SUBJECT: COMANCHE PEAK NUCLEAR POWER PLANT, UNITS 3 AND 4
DOCKET NUMBERS 52-034 AND 52-035
RESPONSES TO REQUESTS FOR ADDITIONAL INFORMATION
NO. 2765, 2954, 3074, AND 3558

Response to Request for Additional Information No. 2765 (CP RAI #73)

QUESTIONS for Component Integrity, Performance, and Testing Branch 1 (AP1000/EPR Projects) (CIB1)

Figure 3.11-1 Project EQ Program Implementation Framework

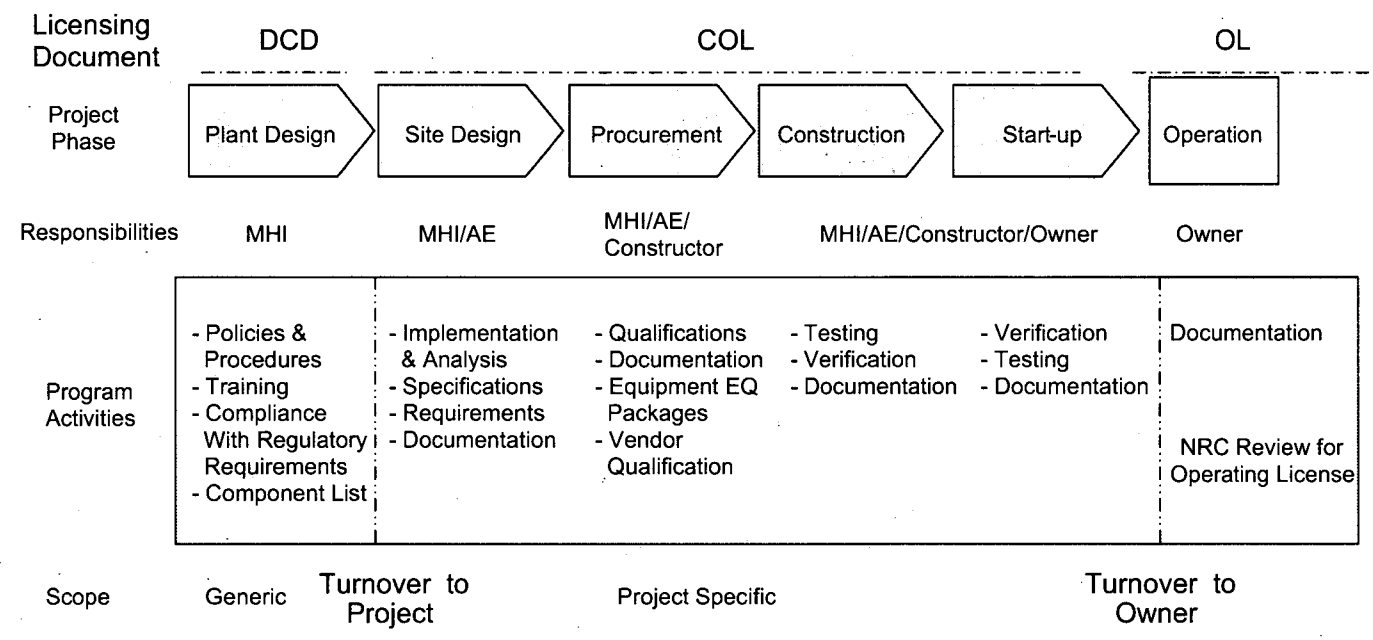
US-APWR DCD Tier 2, Subsection 3.11.1.2, "Definition of Environmental Conditions," states that the COL Applicant may revise the environmental parameters indicated in the DCD based on site-specific considerations. Comanche Peak FSAR Subsection 3.11.1.2 of the same title states that any parameters based on site-specific considerations are identified in the EQ documentation described in Section 3.11. Specify any site-specific environmental parameters to be used for the Comanche Peak EQ program that differ from the US-APWR DCD EQ program description.

Luminant and MHI will identify site-specific environmental conditions (parameters) for CPNPP Units 3 and 4 during the detailed design for the project (see DCD Figure 3.11-1). Parameters based on site-specific considerations are documented in the corresponding equipment specifications, drawings, procedures, instructions, and qualification packages. FSAR Subsection 3.11.1.2 has been revised to clarify this.
